# Microcontroller Technical Information

32-Bit Microcontroller V850E/ME2  Usage Restrictions	Document No.	ZBG-CC-07-0022	1/1
	Date issued	October 1, 2007	
	Issued by	2nd Product Solution Group Multipurpose Microcomputer Systems Division Microcomputer Operations Unit NEC Electronics Corporation	
Related documents V850E/ME2 Hardware User's Manual: U16031EJ5V0UD00 (5th edition) V850E1 Architecture User's Manual: U14559EJ3V0UM00 (3rd edition)	Notification classification	√	Usage restriction
			Upgrade
			Document modification
			Other notification

### 32-Bit Microcontroller V850E/ME2 - Usage Restrictions

#### No. 1 Restriction on successive access to SDRAM and SRAM interface device

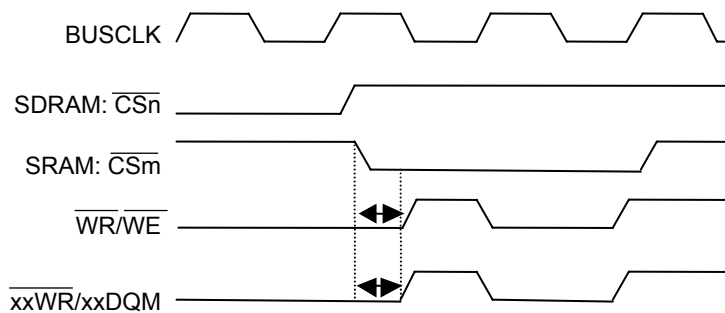
When an access to the SRAM interface device occurs immediately after an access to the SDRAM occurs, the data written to the SRAM interface device may be incorrect.

When an access to the SRAM interface device occurs immediately after an access to the SDRAM occurs, the rise (inactive timing) of the xxDQM (xxWR) signal or WE (WR) signal overlaps the SRAM interface device cycle, which may cause erroneous write (see the figure below).

Erroneous write may occur because the  $\overline{CSn}$  signal of the SDRAM falls before the  $\overline{xxWR/xxDQM}$  and  $\overline{WR/WE}$  signals rise.

- SRAM access immediately after SDRAM access

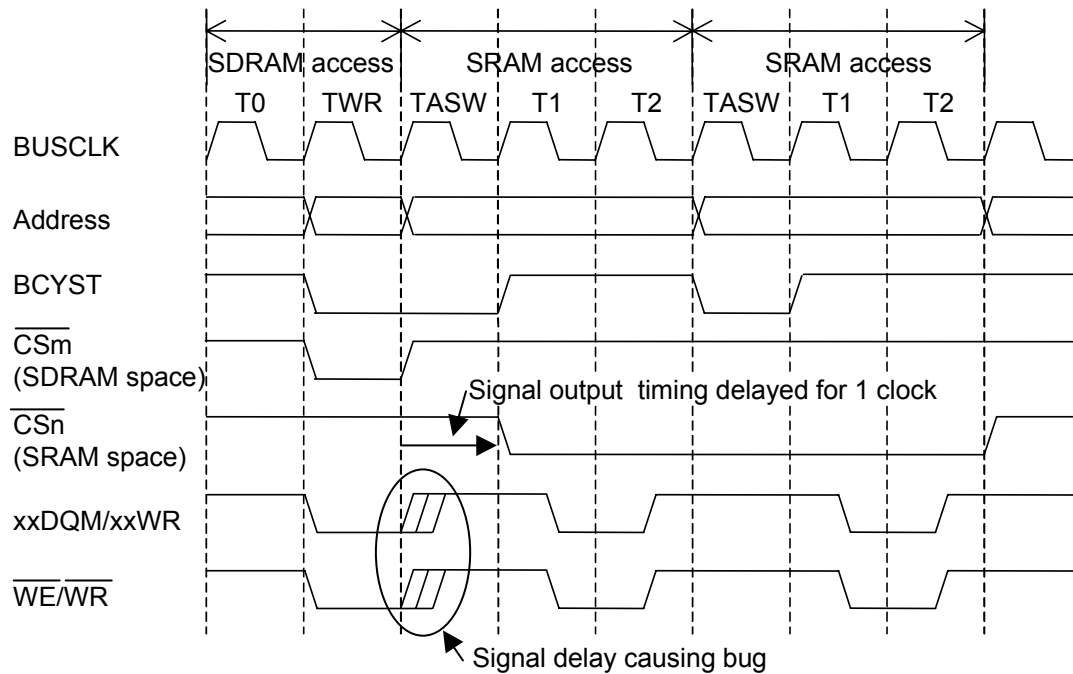
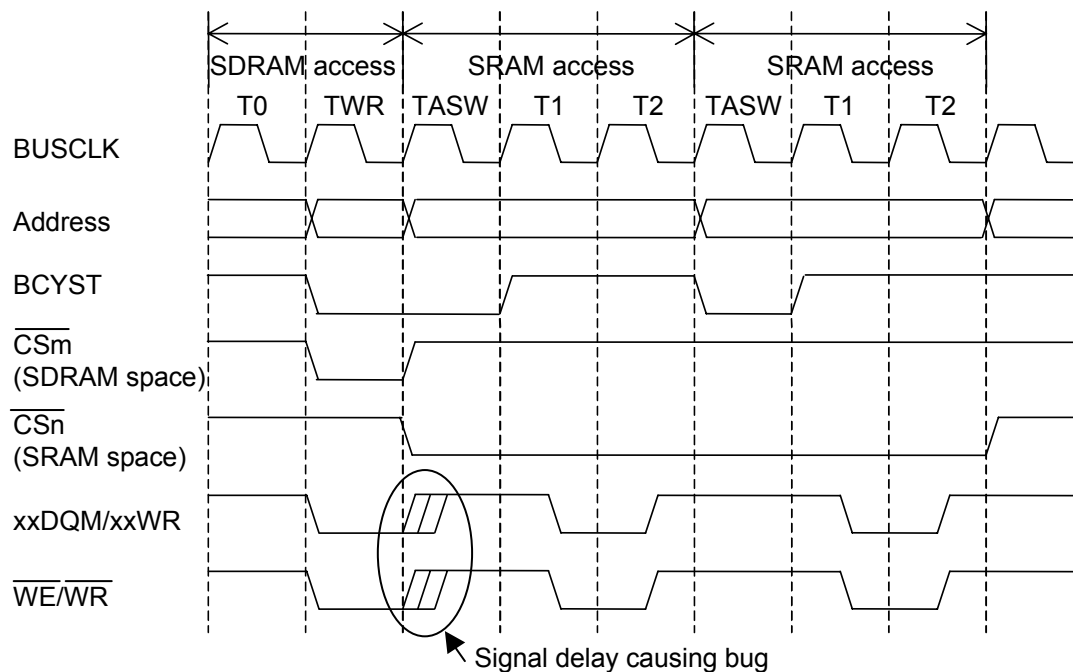
SRAM settings: Address setup waits = 1, data waits = 0, CSCDn = 1

1. CSCDn = 1 (When a CS signal in SRAM cycle is delayed for 1 clock)

2. CSCDn = 0 (When no additional function is used)

The following function has been added to bits 0, 4, 6, and 7 of the PFCCS register in products of rank E or later.

Bit position	Bit name	Function
0, 4, 6, 7	CSDCn	When this bit is set (1), the timing at which the corresponding chip select signal (CSn) falls is delayed by one clock. The output timing of signals other than CSn is not affected.

## (2) Illegal output of HLDAC signal

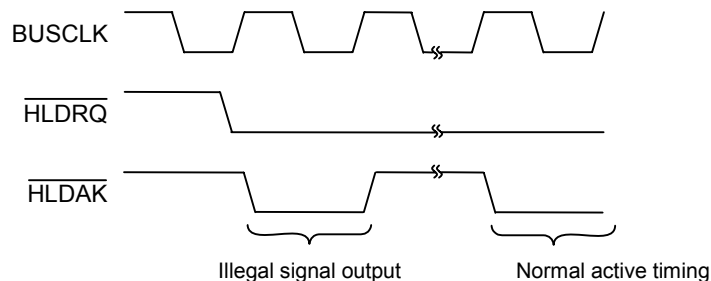
When one of the following operations and an active level input (fall) to the HLDRQ pin conflict, the HLDAC signal may become active for 1 BUSCLK illegally, then inactive, and active again after several BUSCLKs have elapsed (the second active operation is the normal HLDAC signal operation) (see the figure below).

**[Details]**

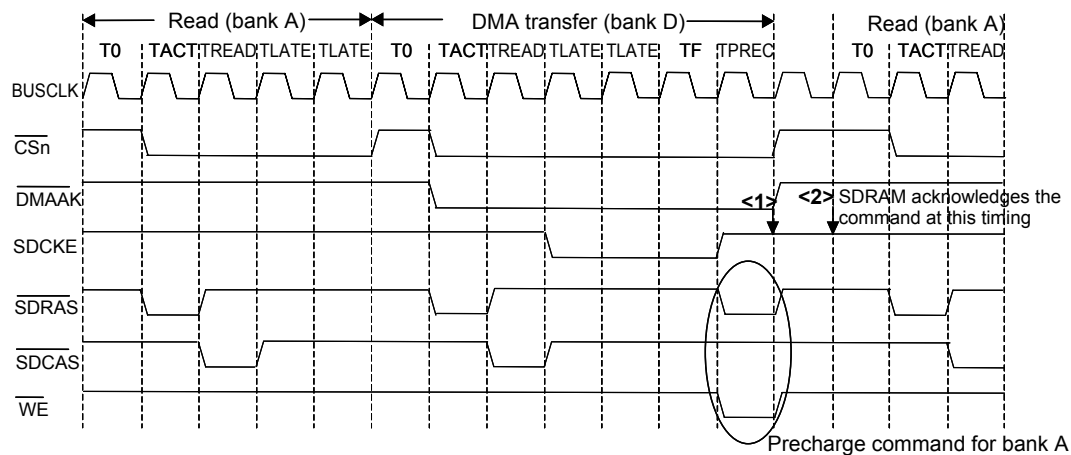
The V850E/ME2 controls waits when performing flyby DMA transfer to the SDRAM by inactivating the SDCKE signal (L level). When the SDRAM has accessed a bank (hereafter referred to as A) and this is followed by a DMA transfer to another bank (hereafter referred to as D), the V850E/ME2 activates the SDCKE signal (H level) and subsequently issues a precharge command (<1> in the figure below). However, the SDRAM can acknowledge commands only at the fall of the clock immediately after the H level of the SDCKE signal is detected (<2> in the figure below). Consequently, the precharge command output from the V850E/ME2 is not acknowledged, and the SDRAM access to bank A performed after the DMA transfer becomes illegal.

Use 2-cycle transfer instead of flyby transfer when performing DMA transfer from the SDRAM to external I/O.

##### • Detailed timing at which this bug occurs

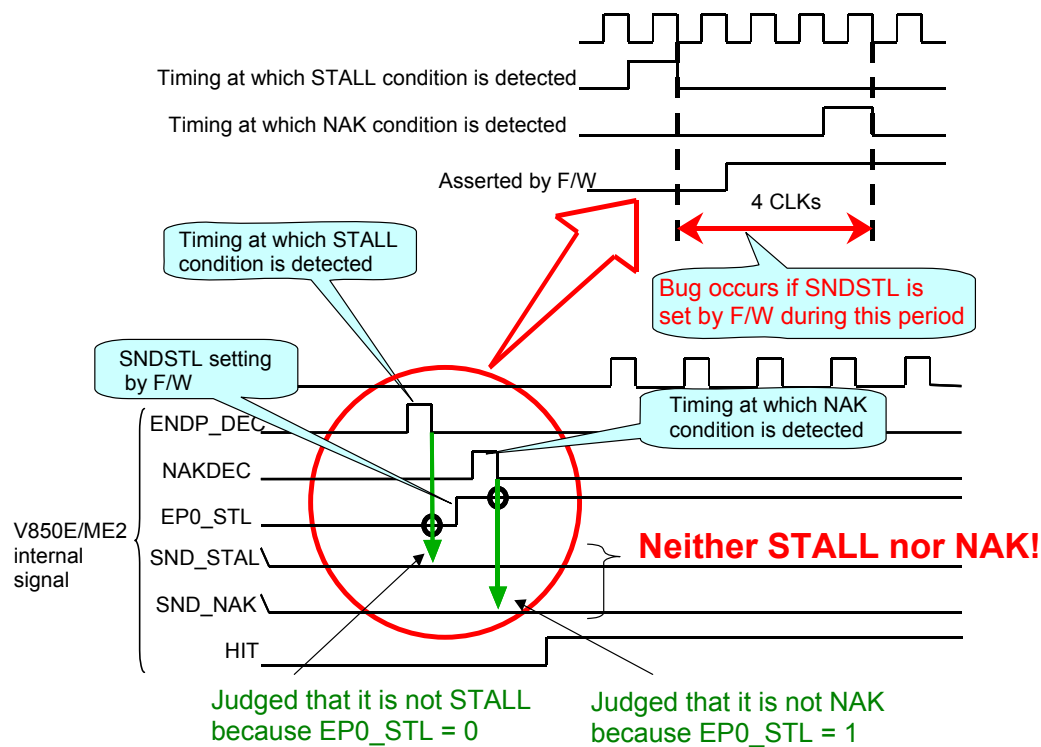
When using the USB function of the V850E/ME2, there is a 4-USB-clock difference between the timing at which the STALL acknowledgment ready status is detected in the device and when the next NAK response is detected. If the SNDSTL bit of the UF0SDS register is set by software during this 4-USB-clock period, neither STALL nor NAK is recognized, which causes this bug.

Design the host driver so that a device request that is not recognized by the function driver is not output.
